UNITED STATES PATENT AND TRADEMARK OFFICE

APPLICATION NO.	FILING DATE	FIRST NAMED INVENTOR	ATTORNEY DOCKET NO.	CONFIRMATION NO.
10/076,522	02/19/2002	Yoshitaka Matsuyama	219499US3	1678
22850	7590	10/29/2003		
OBLON, SPIVAK, MCCLELLAND, MAIER & NEUSTADT, P.C. 1940 DUKE STREET ALEXANDRIA, VA 22314			EXAMINER HYEON, HAE M	
			ART UNIT	PAPER NUMBER
			2839

Office Action Summary

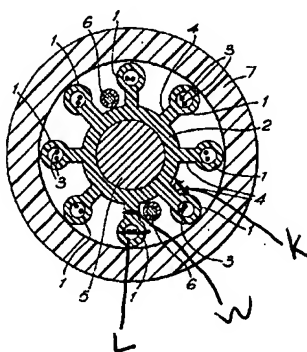
3. Claims 1-10 and 16 are rejected under 35 U.S.C. 103(a) as being unpatentable over Emery (EP-0189666) in view of the present specification page 19, lines 7-10.

Emery discloses an optical fiber cable comprising two or more optical fibers 3, a plurality of electrical conductors 6, a tension member 5, and a partitioning spacer 2 housed in a space encircled by a sheath 7. The partitioning spacer 2 includes an axial portion and a plurality of partitioning plate portions 4. The partitioning spacer 2 also has a sectional shape that the partitioning plate portions radially extend toward an inner circumferential surface of the sheath from the axial portion. Each of the partitioning plate portions has a leading end provided with an enlarged portion 1 in contact with the inner circumferential surface of the sheath 7 and a connecting portion connecting the enlarged portion 1 to the axial portion, where in the enlarged portion 1 has a substantially circular shape in cross section. Figure 1 of Emery clearly shows the enlarged portion 1 having a maximum dimension L in a direction perpendicular to a radial direction, each of the connecting portions having a length K in the radial direction, each of the

connecting portions having a dimension W in the direction perpendicular to a radial direction, and each of the optical fibers having an outer diameter R . Although Emery does not describe the sectional shape of the partitioning spacer, it clearly has the following relations (1) and (2).

(1) $L - W \geq R$ and (2) $K \geq R$

While the optical fibers 3 are arranged in-group of two fibers and separated from the tension member 5, the optical fibers 3 and the tension member 5 are not distributed in the partitioned slots. However, distributing the optical fibers 3 and the tension member 5 within the partitioned slots only deals with rearrangement of parts. Page 4, line 25-30, Emery states that the optical fibers 3 are not required to be housed in the tube 1 (enlarged portion). It has been held that rearranging parts of an invention involves only routine skill in the art. *In re Japikse*, 86 USPQ 70. It has been held that rearranging parts of an invention involves only routine skill in the art. *In re Japikse*, 86 USPQ 70. Furthermore, Emery does not disclose the sheath 7 having the characteristics recited in claims 4 and 5, but the present specification page 19, lines 7-10 states that the sheath recited in claims 4 and 5 already exists.
